Title - Sujet Sally Port Gates and Fence Repair	
Solicitation No. - N° de l'invitation EV385-160418/B	Amendment No. - N° modif. 002
Client Reference No. - N° de référence du client csc EV385-160418	Date 2015-08-24
GETS Reference No. - N° de référence de SEAG PW-\$PWU-183-10530	
File No. - N° de dossier PWU-5-38073 (183)	CCC No./N° CCC - FMS No./N° VME
Solicitation Closes - L'invitation prend fin at - à 02:00 PM on - le 2015-09-11	Time Zone Fuseau horaire Mountain Daylight Saving Time MDT
F.O.B. - F.A.B. Plant-Usine: <input type="checkbox"/> Destination: <input type="checkbox"/> Other-Autre: <input type="checkbox"/>	
Address Enquiries to: - Adresser toutes questions à: Tikhonovitch (RPC), Alex	Buyer Id - Id de l'acheteur pwu183
Telephone No. - N° de téléphone (780) 901-7940 ()	FAX No. - N° de FAX (780) 497-3510
Destination - of Goods, Services, and Construction: Destination - des biens, services et construction:

See attached the Addendum #1

A + ID [COURTNEY + KRAMER] 101, 4632 1ST SE, CALGARY, AB, T2G 2L3 TEL: 403.289.7109, 403.289.7595	Project SALLYPORT GATE AND FENCE REPAIR		Designed by GK	project no. R-058016.001	sheet SK-1.01
	Drawing Title SK ADDENDUM 1.01		Drawn by GK	scale

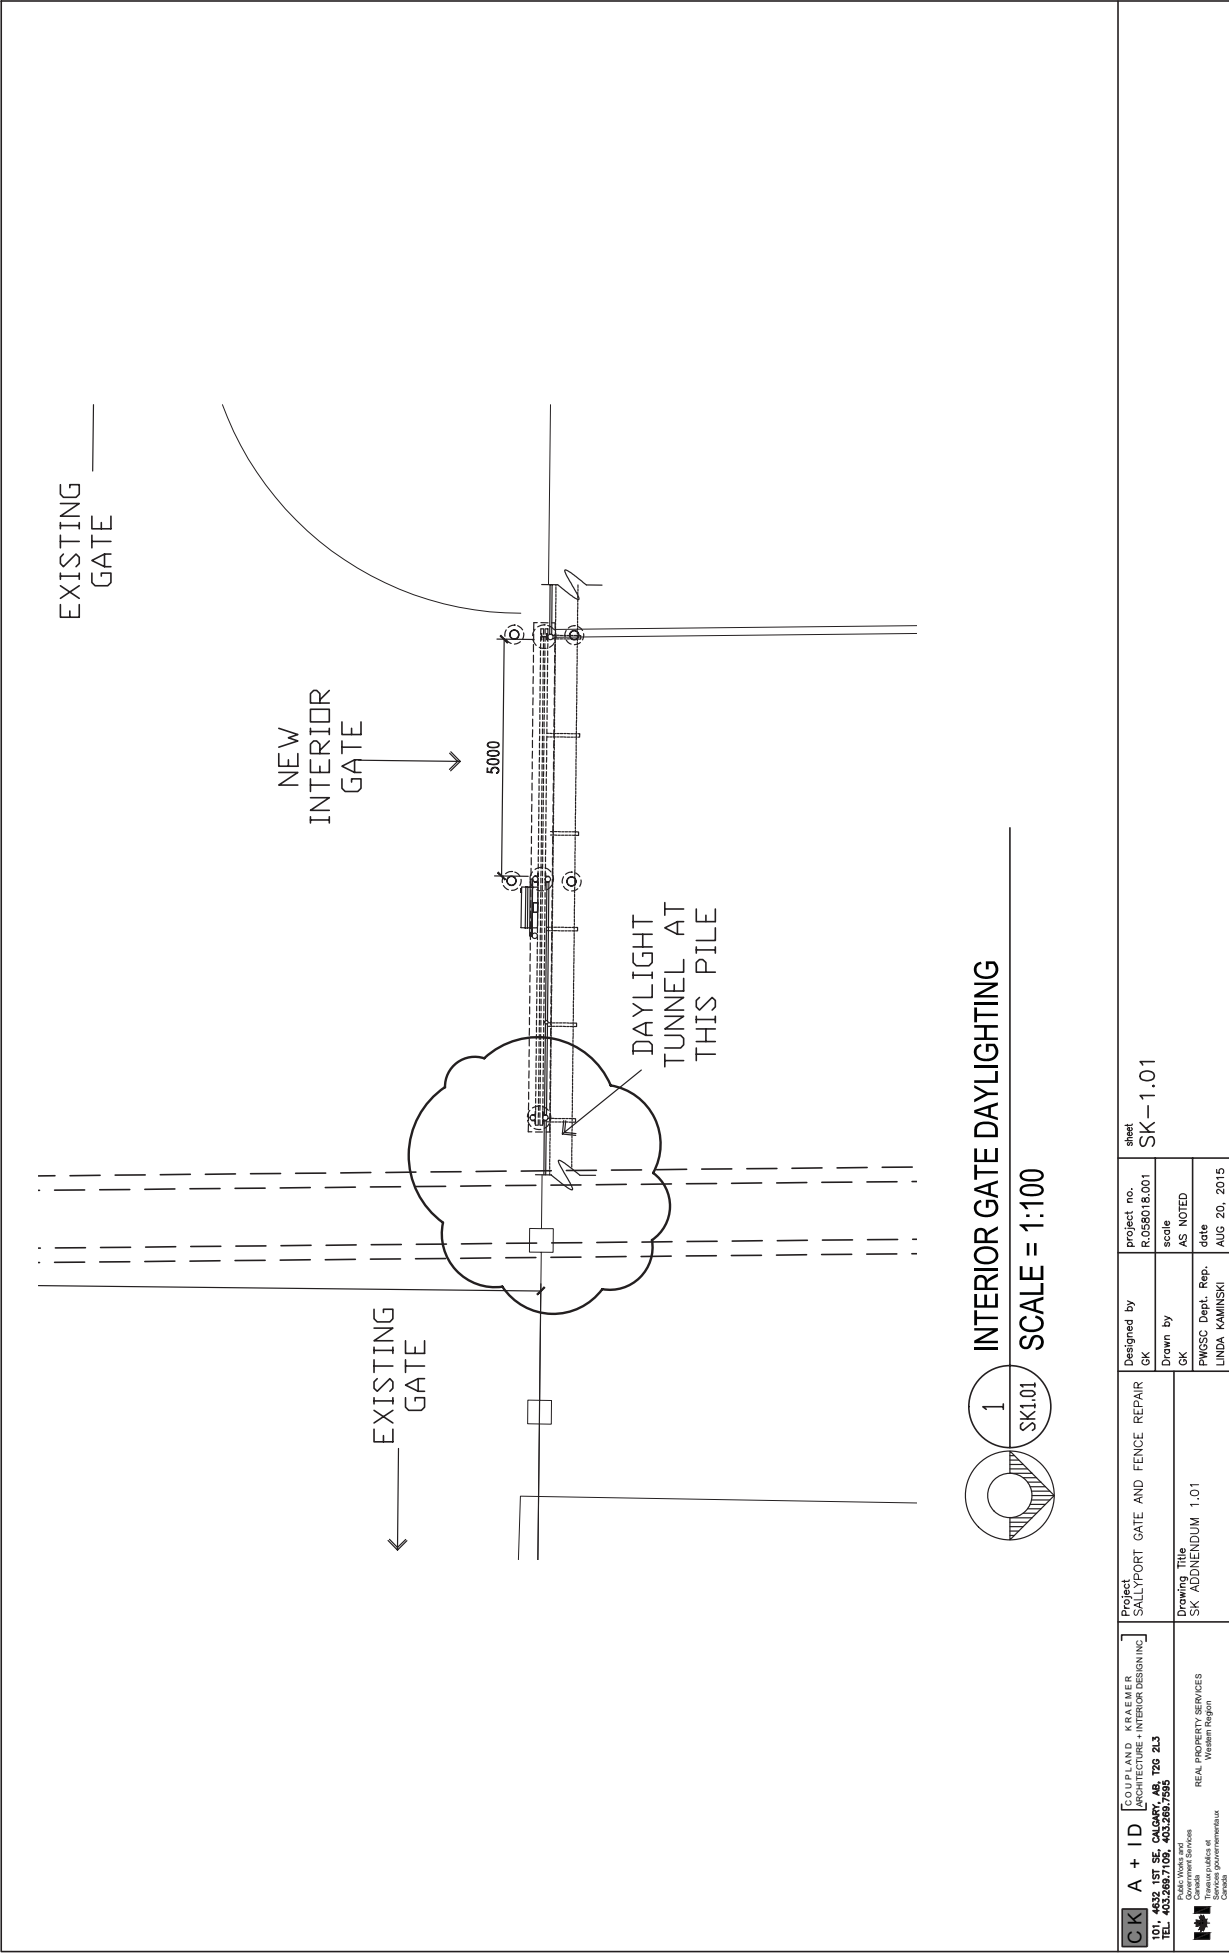
5.1.	<p>Refer to attached sketch SK-1.01</p> <ol style="list-style-type: none">1. To ensure the below grade utilities tunnel is properly located, hydro-vacuum the area located as indicated on the attached sketch to ensure pile is clear of tunnel prior to any foundation work.
------	--
